TOWN OF BLUFFTON

STAFF REPORT Department of Growth Management

| PROJECT: | Cypress Ridge Commercial Building, RV and Boat Storage and Phase 7 Buffer Certificate of Appropriateness Highway Corridor Overlay |

1. **COFA-06-16-9716.** A Certificate of Appropriateness to permit the construction a commercial office of approximately 4,490 SF, RV and boat storage, and the Phase 7 Buffer along with the associated lighting and landscaping improvements. The property is located at the intersection of Highway 170 and Hulston Landing Road within the Cypress Ridge Development, zoned PUD, and lies within the Cyprus Ridge/Jones Estate PUD.

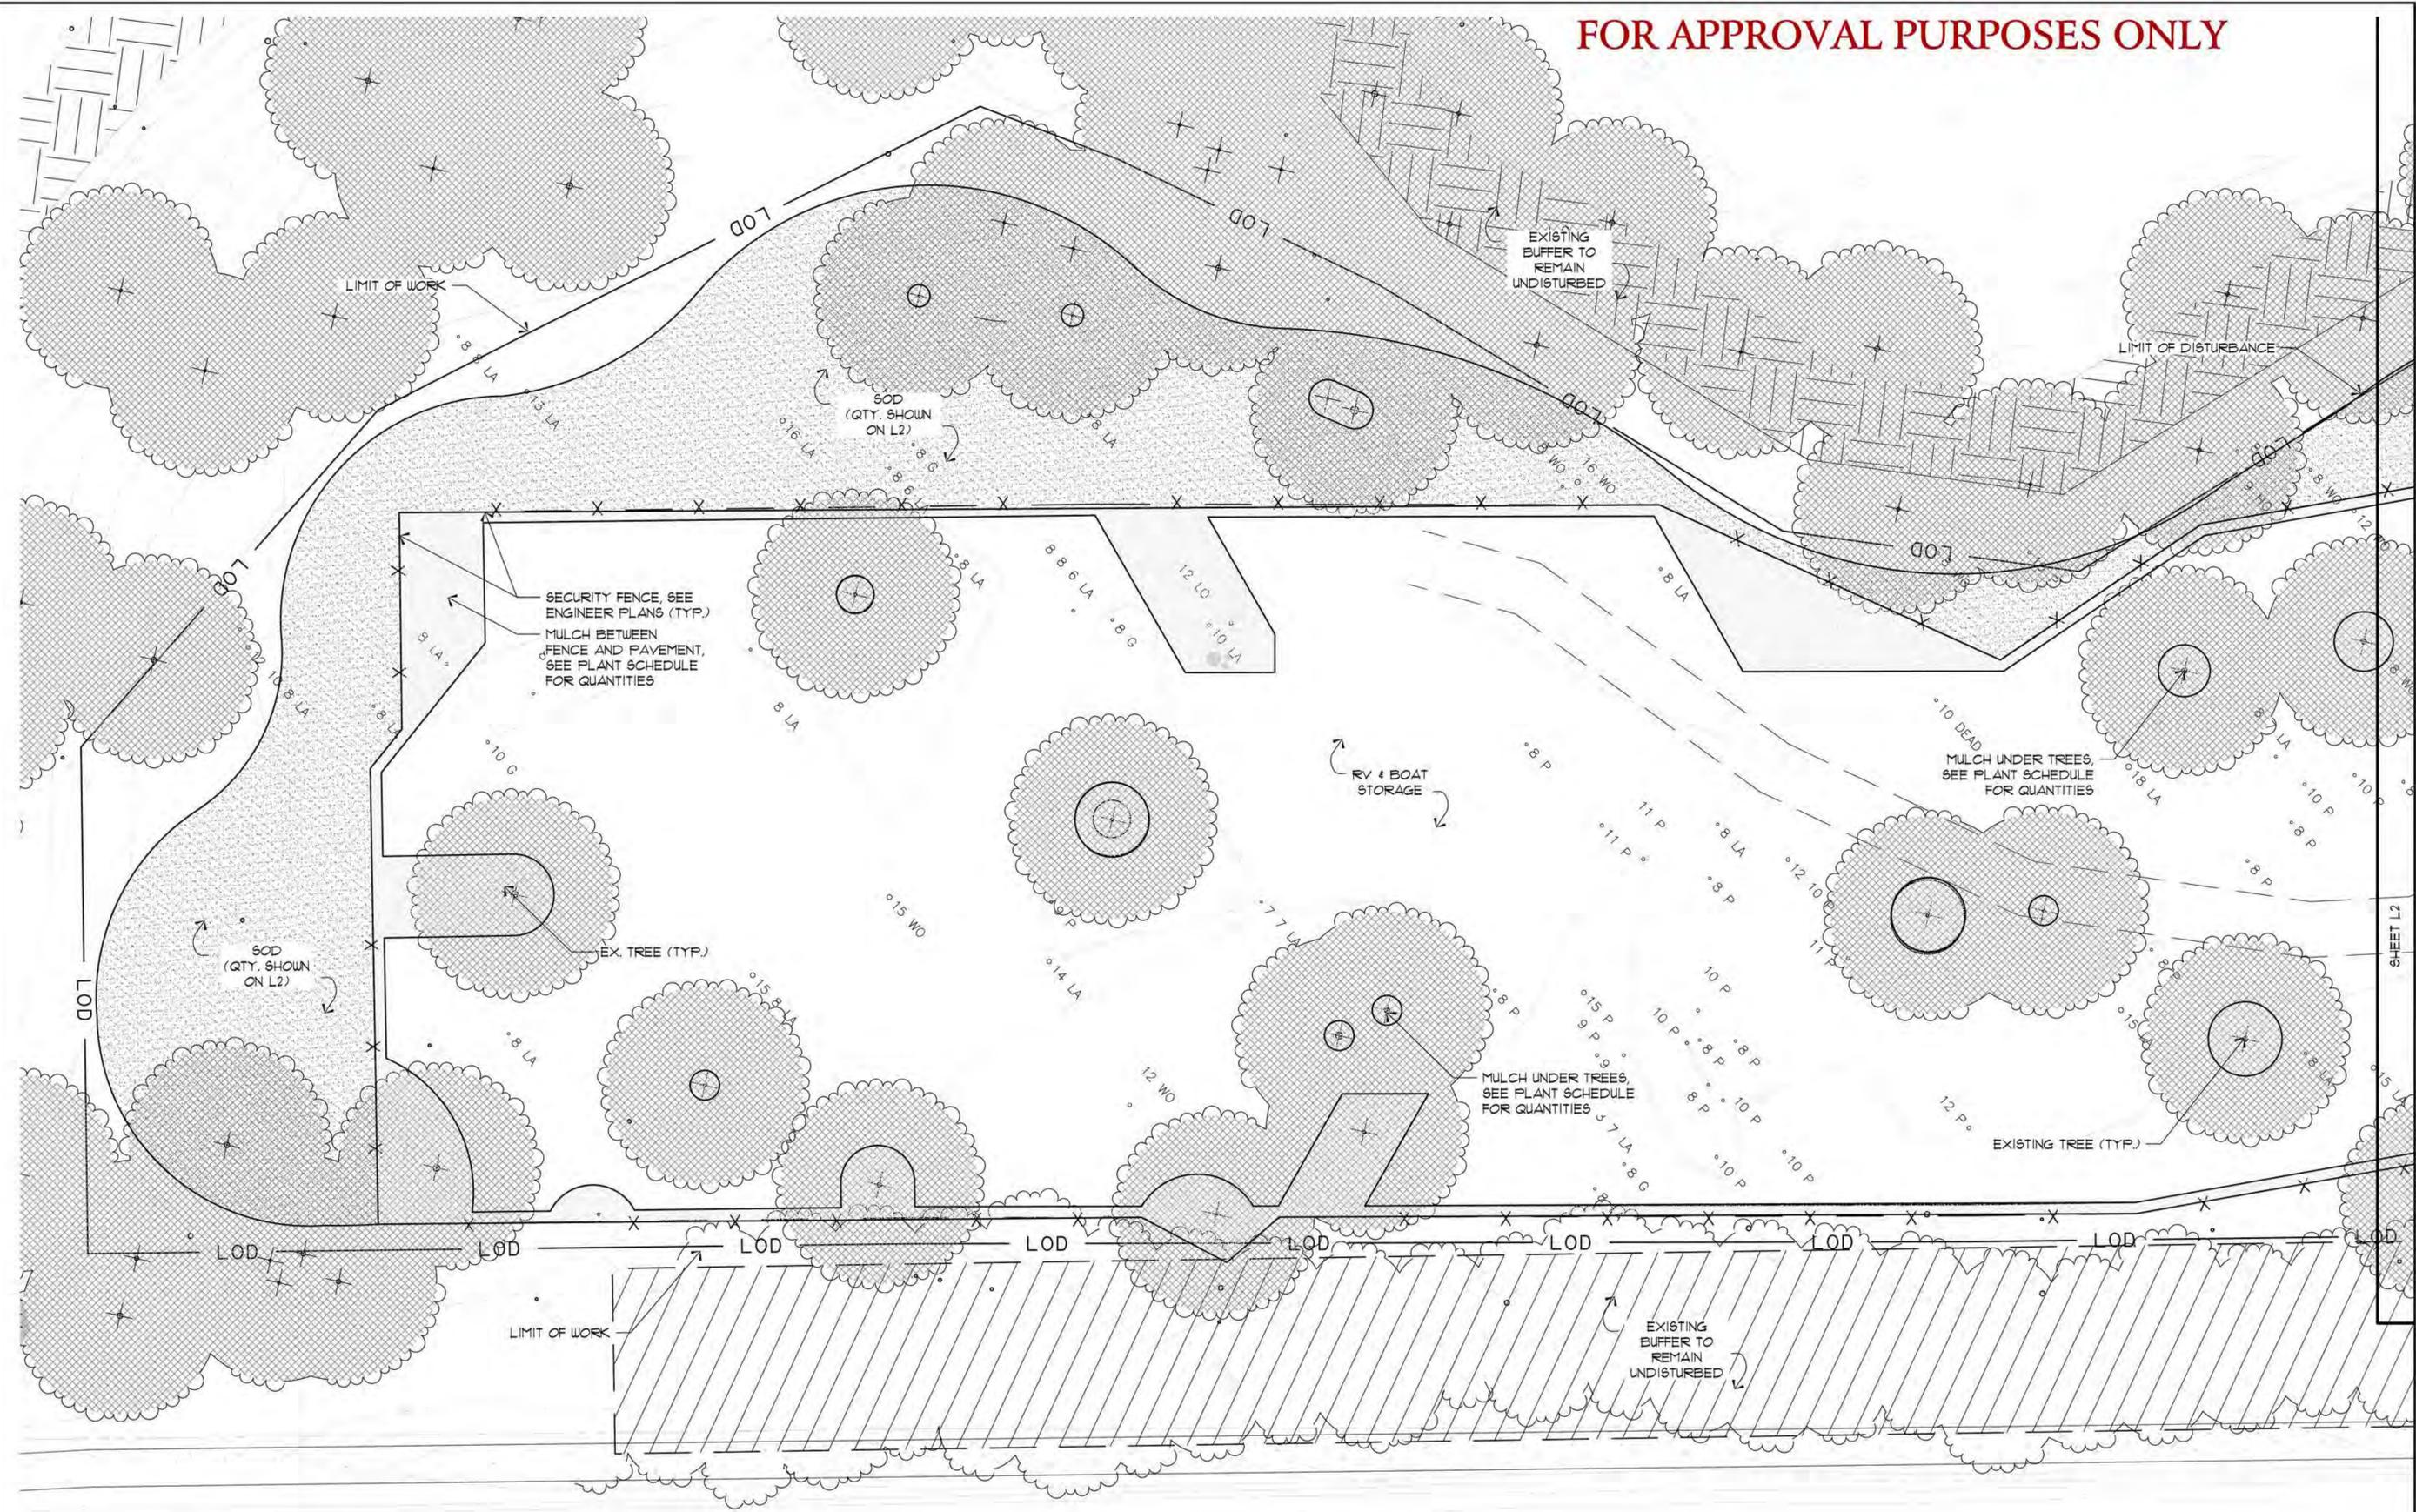
- 1) Finding – Highway Buffers. Section 4.24.2.1.A. of the ZDSO requires a 25' wide landscaped buffer parallel to the entire front of the property along the highway right-of-way and contain vegetative landscaping materials. While the applicant is proposing to preserve the existing trees within the 50' highway corridor buffer area, no additional plantings are proposed for the area along the highway right-of-way. The applicant shall comply with the requirement to provide a landscape buffer plan that will achieve a semi-continuous and semi-opaque vertical plane of tree canopy, understory trees and shrubbery coverage.

- 2) Finding – Landscaping. Section 5.24.2.1.C.1 of the ZDSO requires a minimum of six (6) broad-leaved overstory trees, seven (7) understory trees, and thirty (30) shrubs for every 100 linear feet for frontage on the highway. The applicant shall provide a planting plan that confirms compliance with this requirement. Existing vegetation may be used in the calculation in meeting this requirement and proposed tree removal for the entire site should be clearly noted.

- 3) Finding – Applications Manual. The Application for this project requires scaled architectural and site plans for review. There appears to be some discrepancies between the site plans in the architectural plan set and the site plans in the landscape/lighting plan set. In particular, the

configuration of the parking for the commercial building is inconsistent. These drawing sets must be revised for consistency.

1. Landscape.
 - a. Per Section 4.24.2.1.A.of the ZDSO, provide the required plantings within the buffer area.
 - b. Per Section 5.24.2.1.C.1 of the ZDSO indicate the required plantings per 100 linear feet are provided and note proposed tree removal.
 - c. Per the Applications Manual, the architectural site plan and landscaping and lighting site plans must be revised for consistency.
2. Architecture

Sheet Title:
 Lighting Schedule

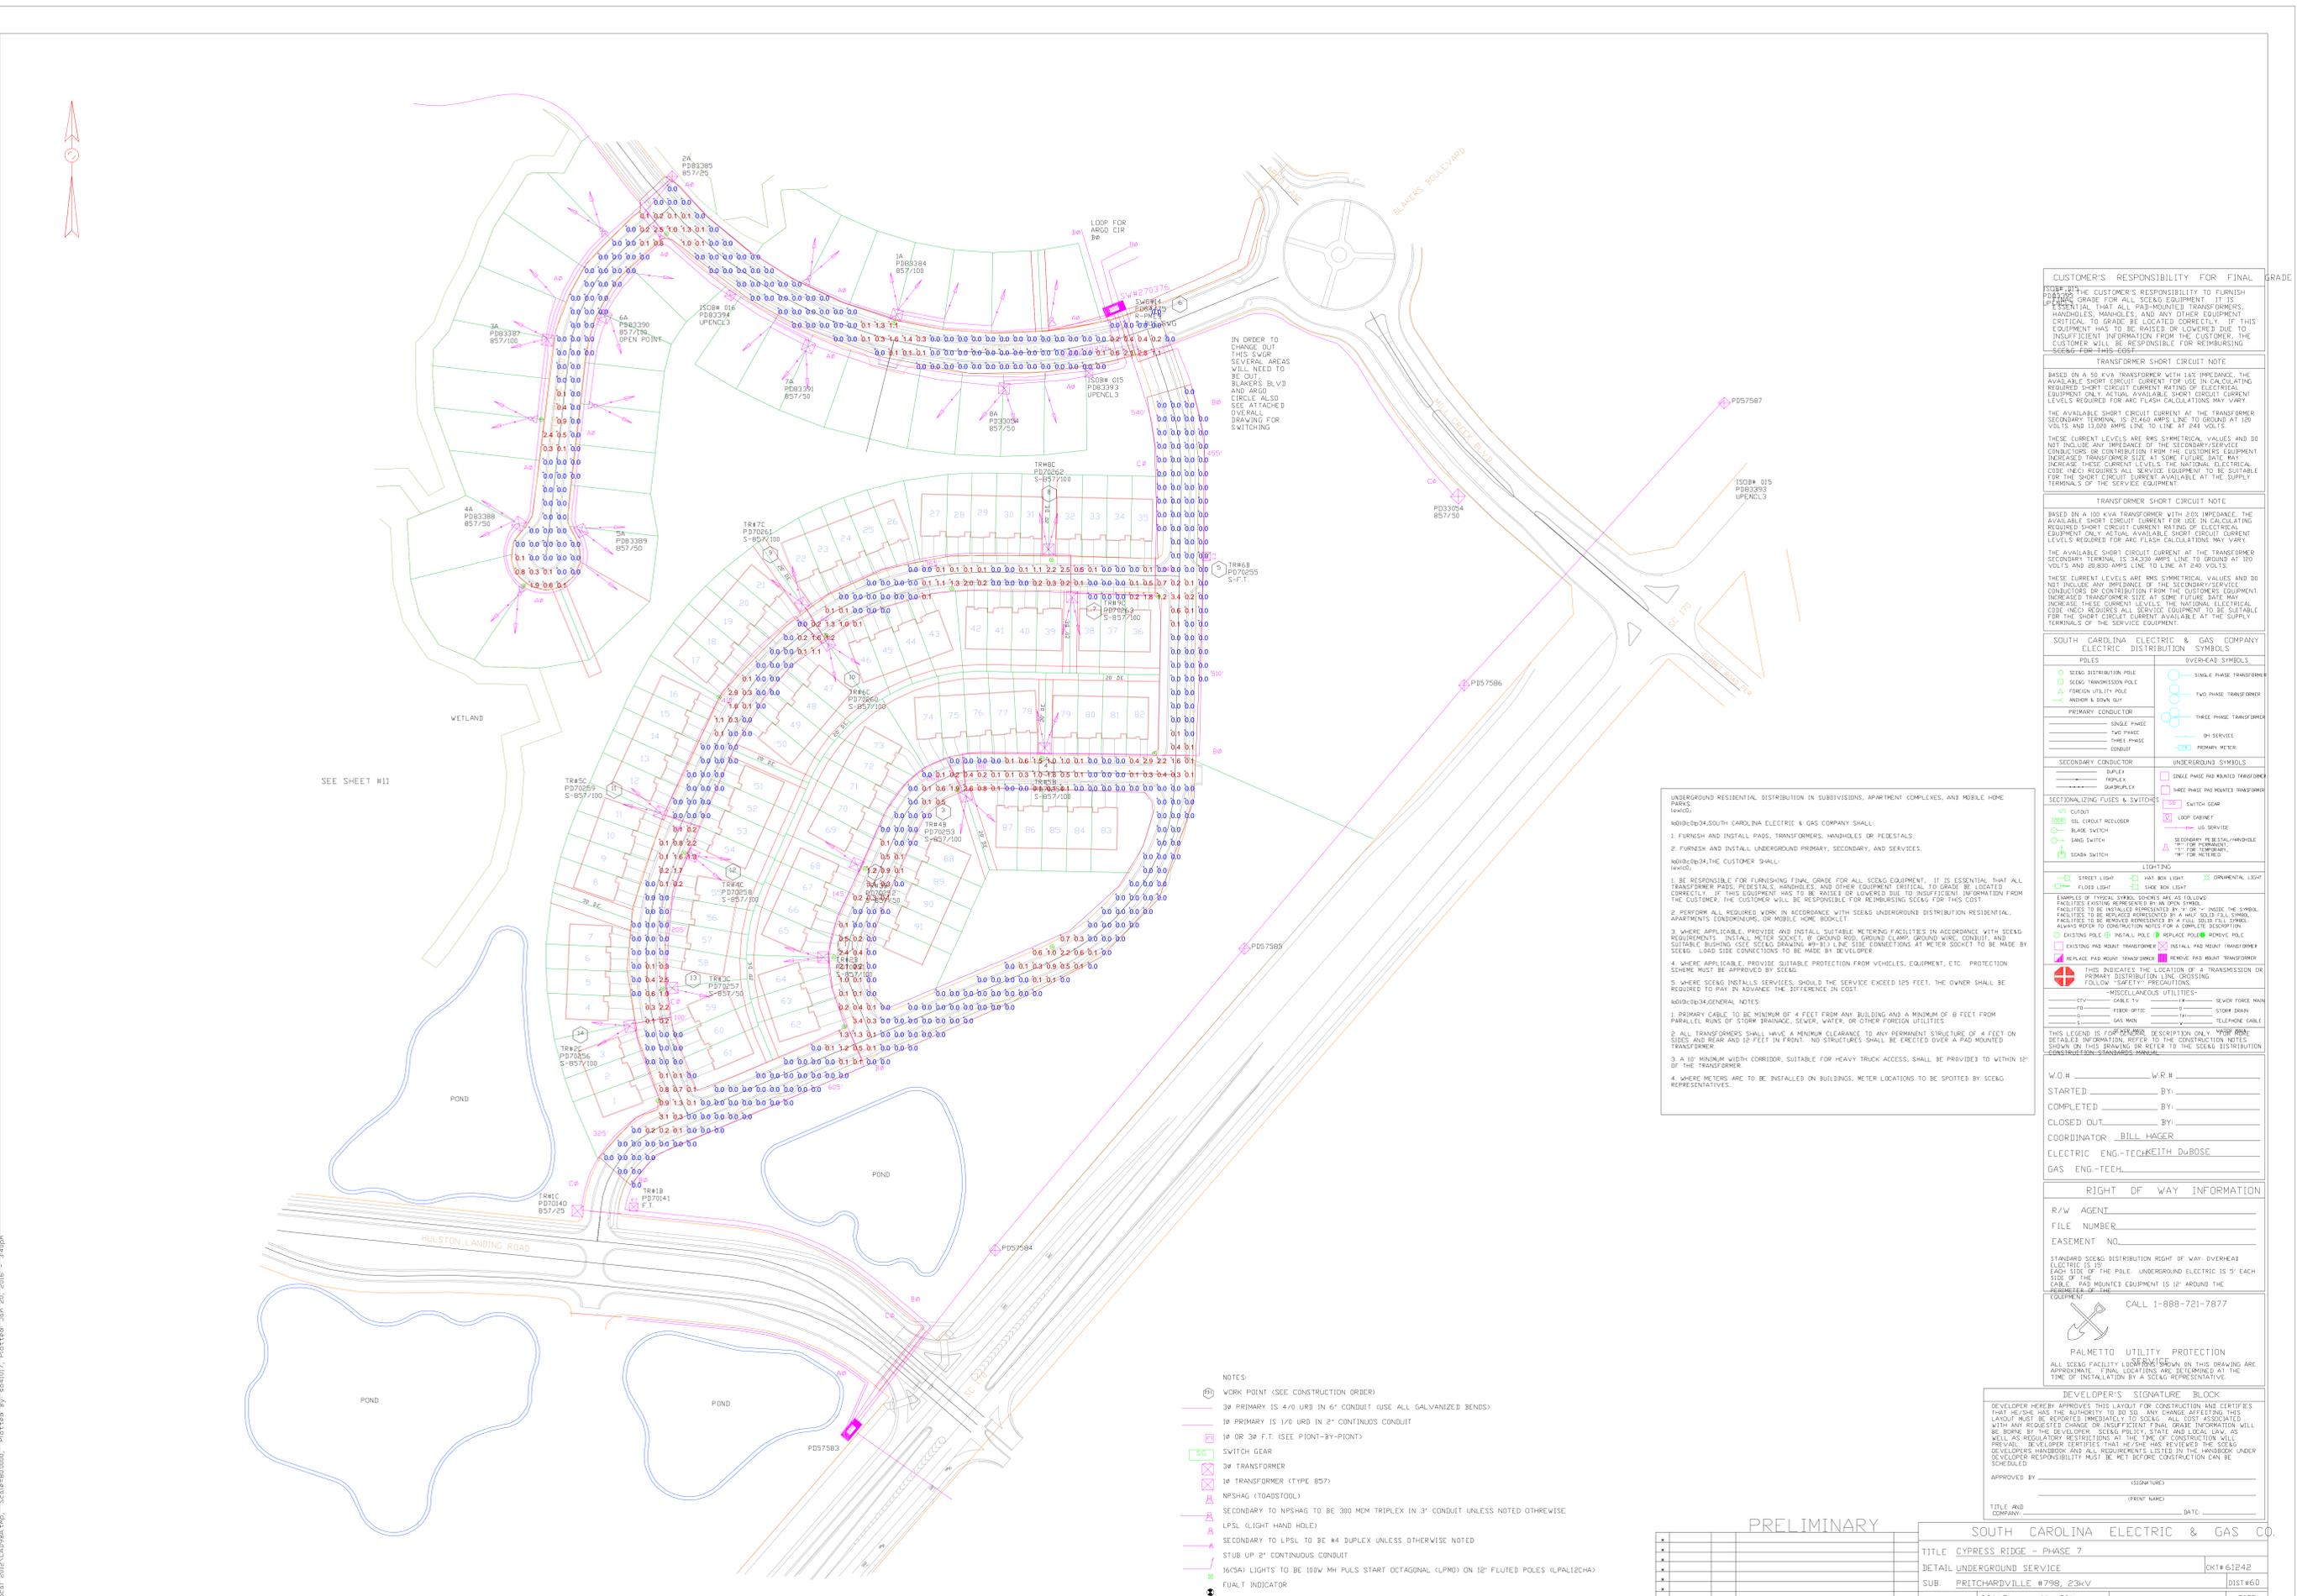
- 1) *Finding – Lighting.* Section 5.15.11 (D) of the TOB HCOD permits lighting for streets and commercial parking areas provided such lighting meets the foot-candle requirements for lighting as provided in Section 4.24.3.C.2.iv. of the ZDSO. The lighting plan shall be revised to include foot-candle information to ensure compliance is achieved for the required minimum illumination levels.

3. Lighting
- a. Per Section 4.24.4.C. of the TOB HCOD, revise the foot-candle illumination information to ensure compliance with Section 4.24.3.C.2.iv. of the ZDSO.
